OFFSHORE OPERATORS COMMITTEE

May 15, 2017

RE: ***Joint Trade Association Comments  
Gulf of Mexico Outer Continental Shelf Lease Sale Draft Supplemental Environmental  
Impact Statement 2018 MMAA10400  
Docket ID: BOEM-2017-0001***

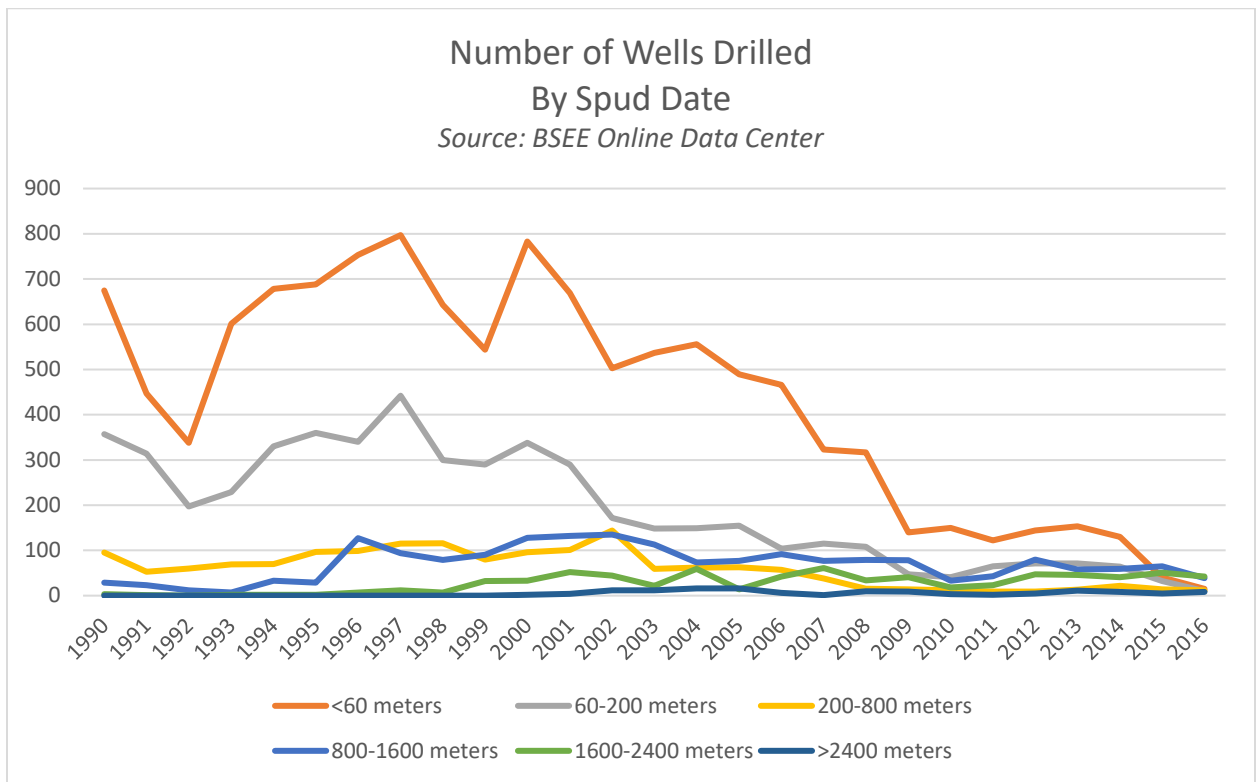
Similarly, the number of wells drilled annually since 1990 has dramatically declined in shallower water depths (less than 200 meters). As the chart below demonstrates, activity as measured by the number of wells drilled is shifting from shallower water depths to deeper waters. Any future projections on platform locations used in the GOM Air Quality Modeling study and Draft SEIS should account for these trends to realistically represent future GOM projections.
